# **ANCLOTE HARBOR**

## **#20-106 [PRELIMINARY PLANNED DEVELOPMENT]**

Board of Commissioners, December 8, 2020 (1st Reading)

**CITY OF TARPON SPRINGS**  
**PLANNING & ZONING BOARD / BOARD OF COMMISSIONERS**  
**November 16, 2020 / December 8, 2020 & December 15, 2020**

Figure 5  
Existing A.M. Peak-Hour Peak Season Traffic  
Anclote Harbor Development  
Tarpon Springs, Florida

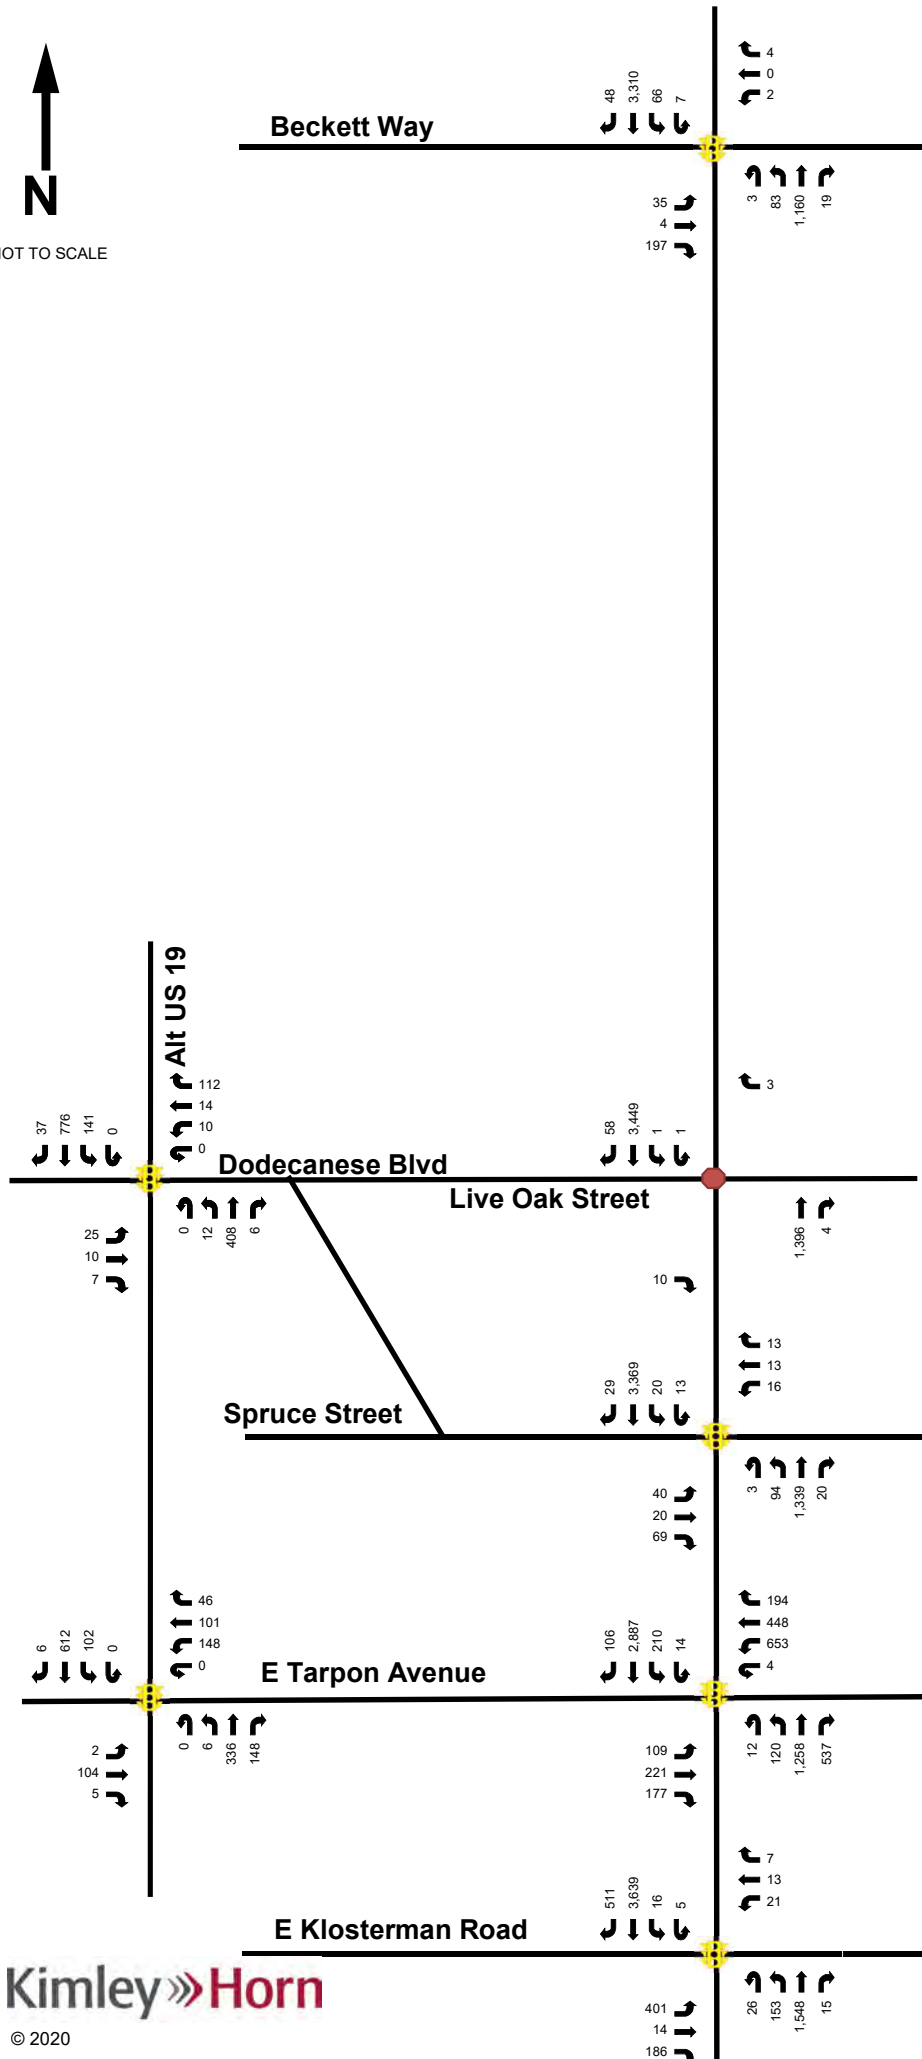
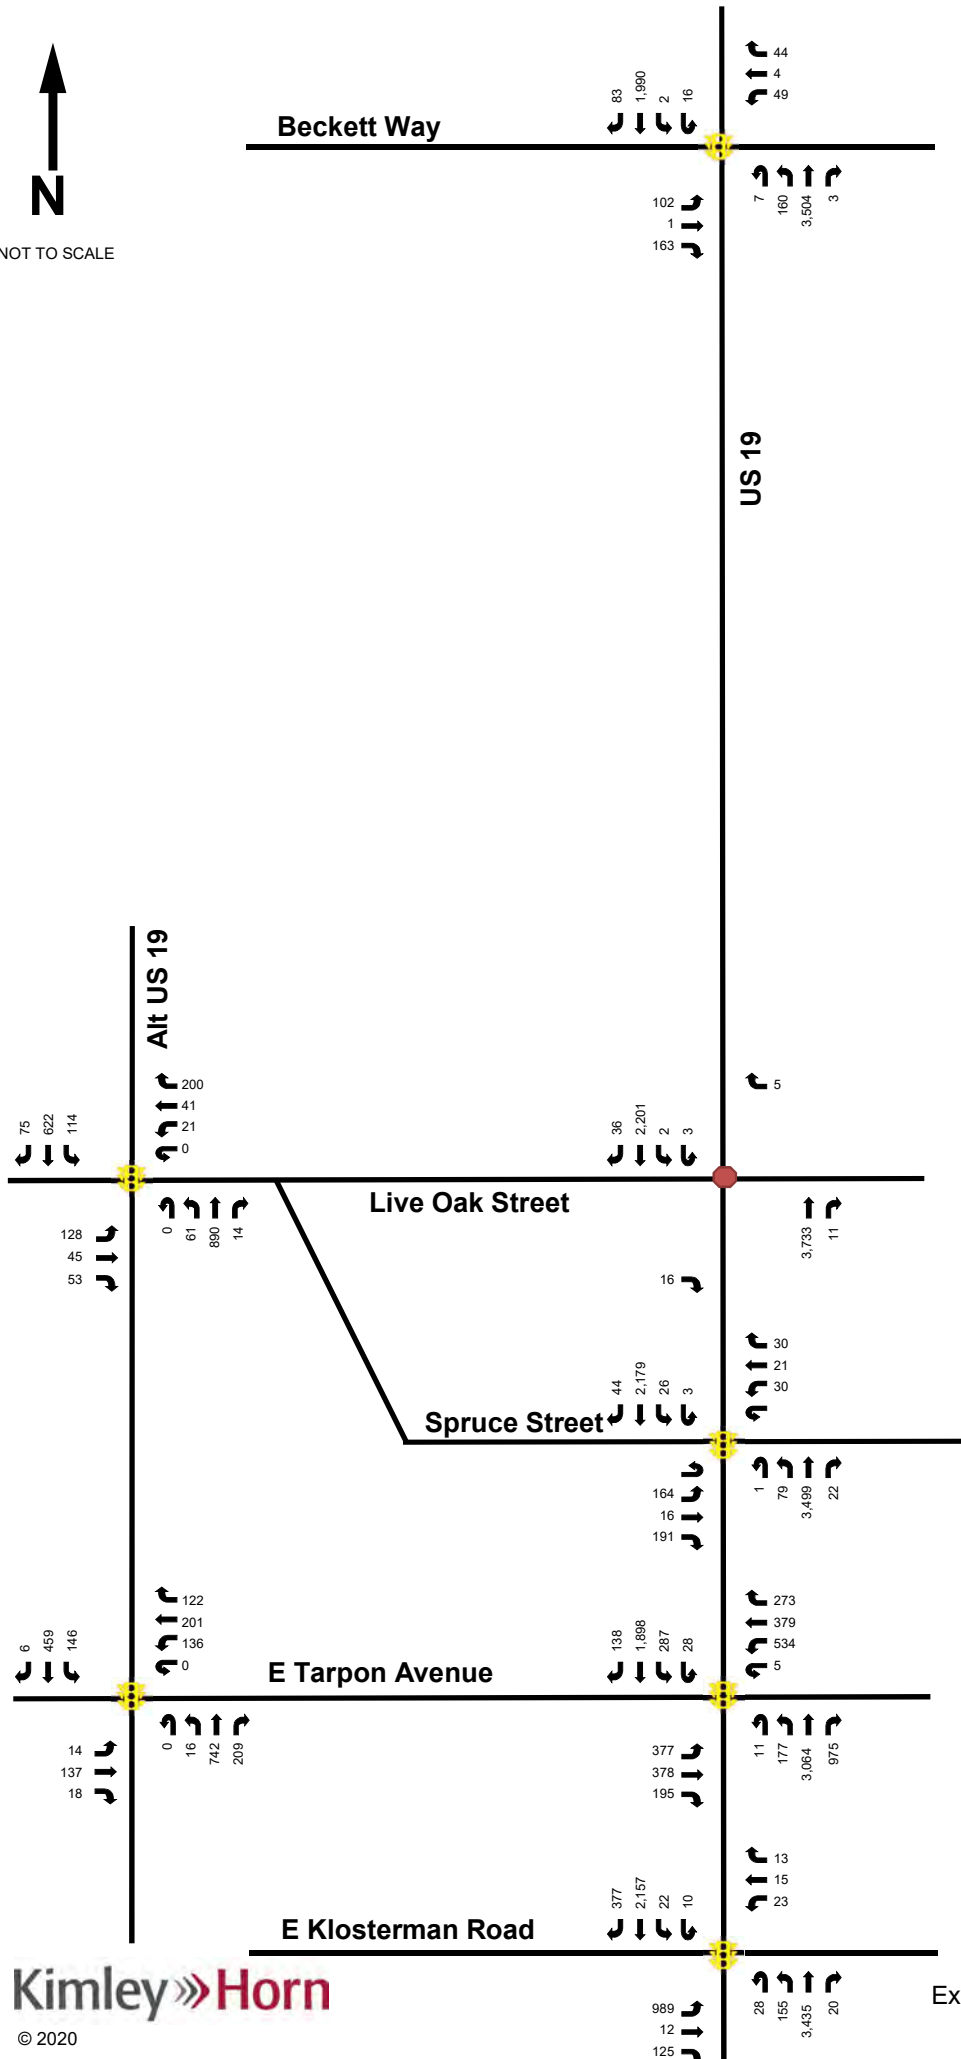
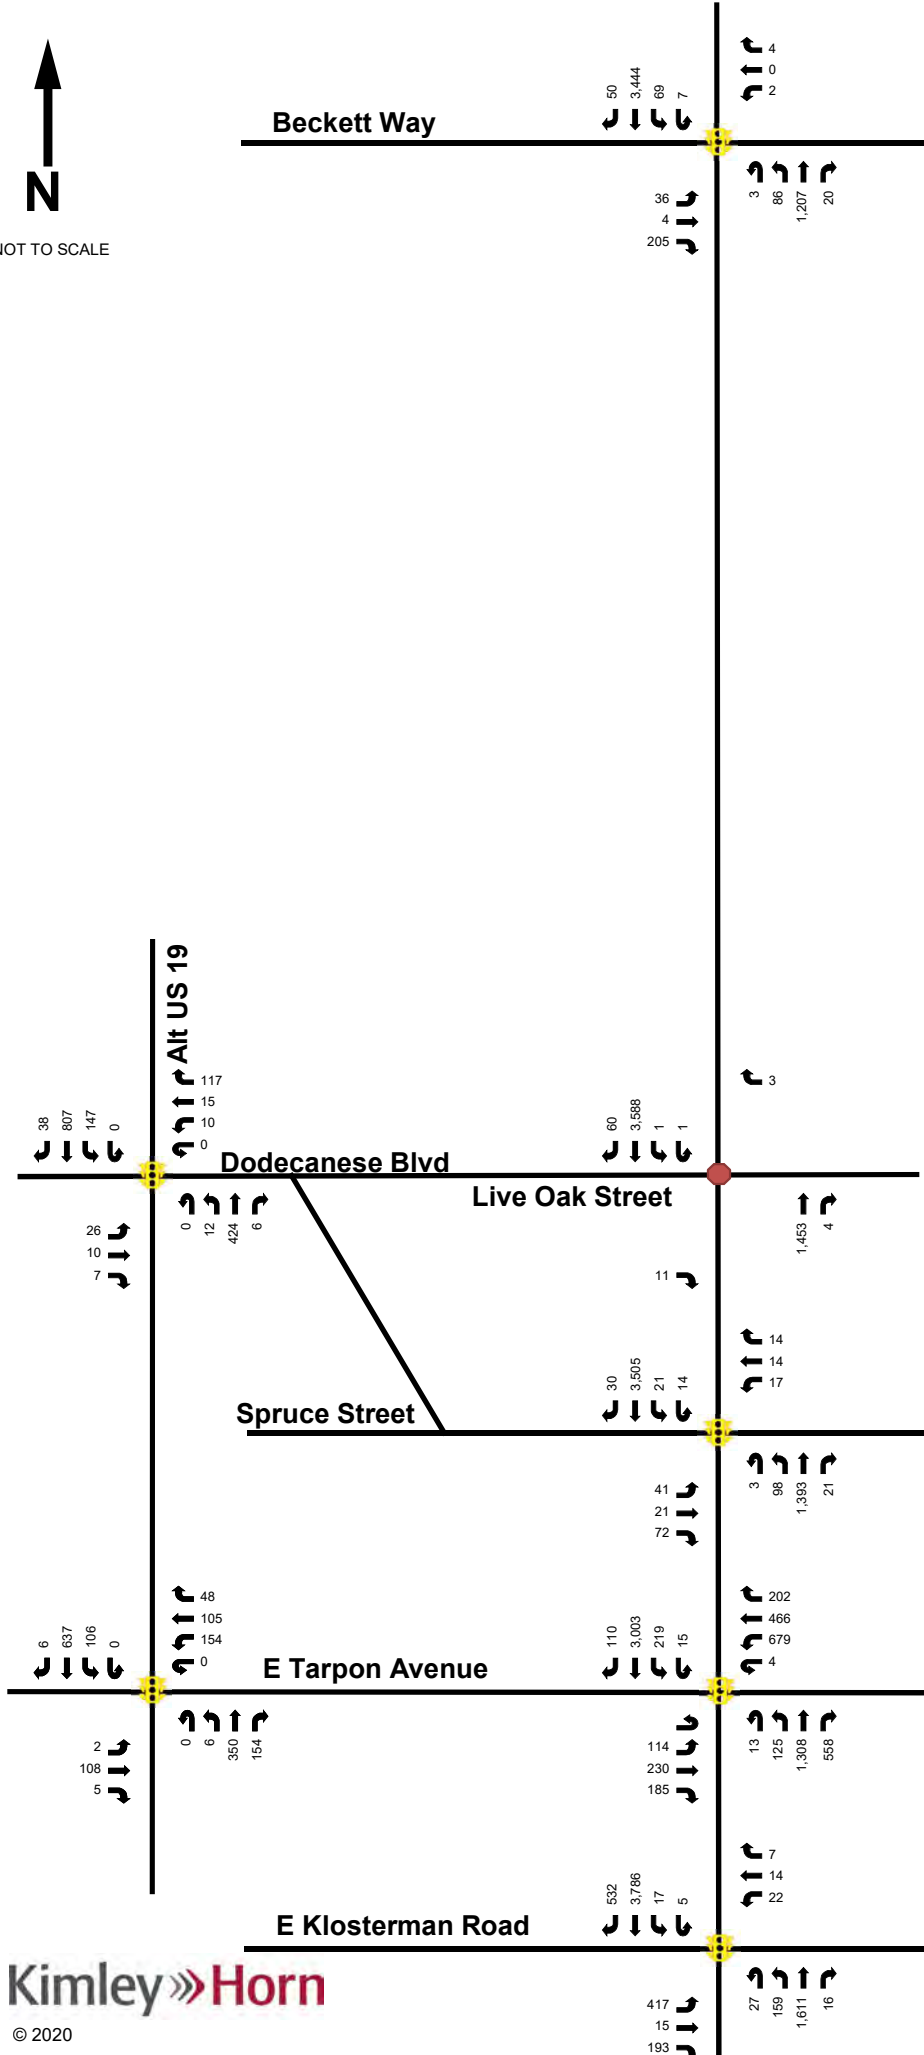
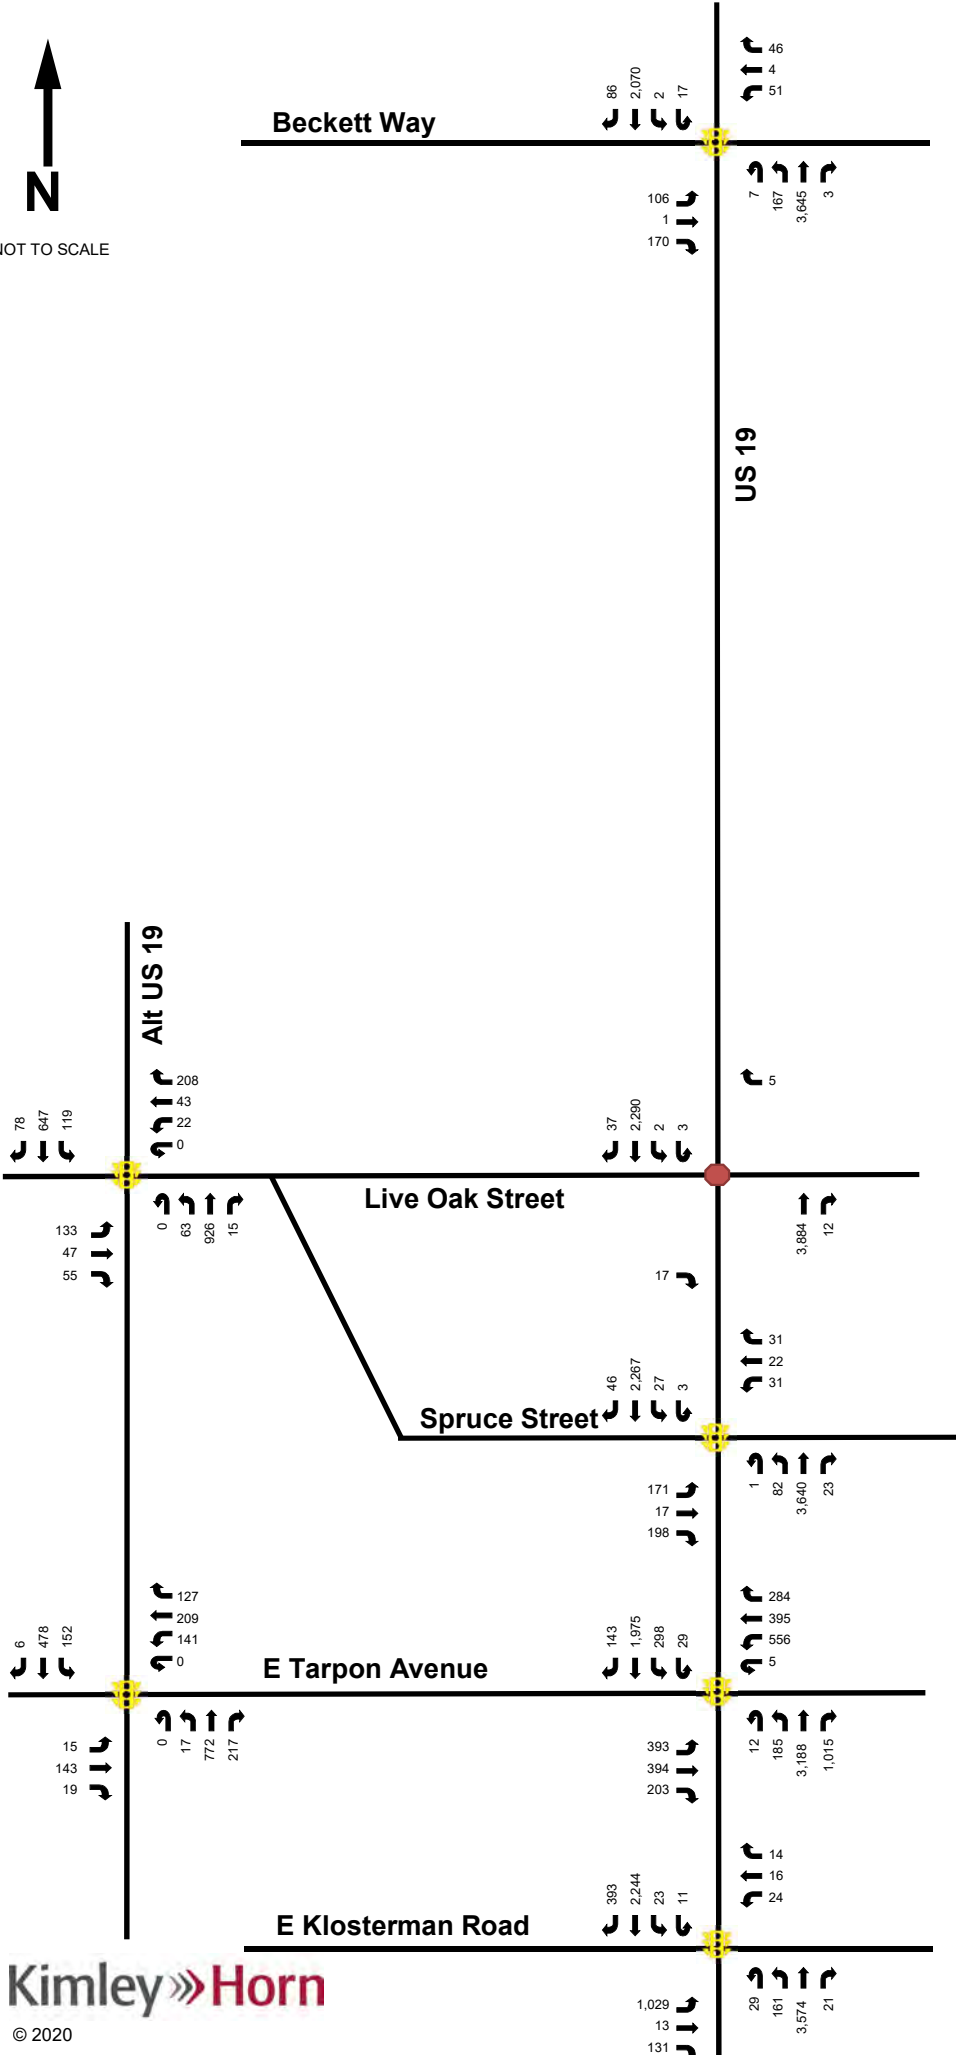
**Comment 9:** Typical Comment - Add link volumes on Figures 5 through 8 between all Study Intersections.

Comment 8: Typical Comment - Determine if comments on Figures 2 through 4, would affect the traffic volumes shown in Figures 5 through 8, and Figures 10, 11.

Comment 9: Typical Comment - Add link volumes on Figures 5 through 8 between all Study Intersections.
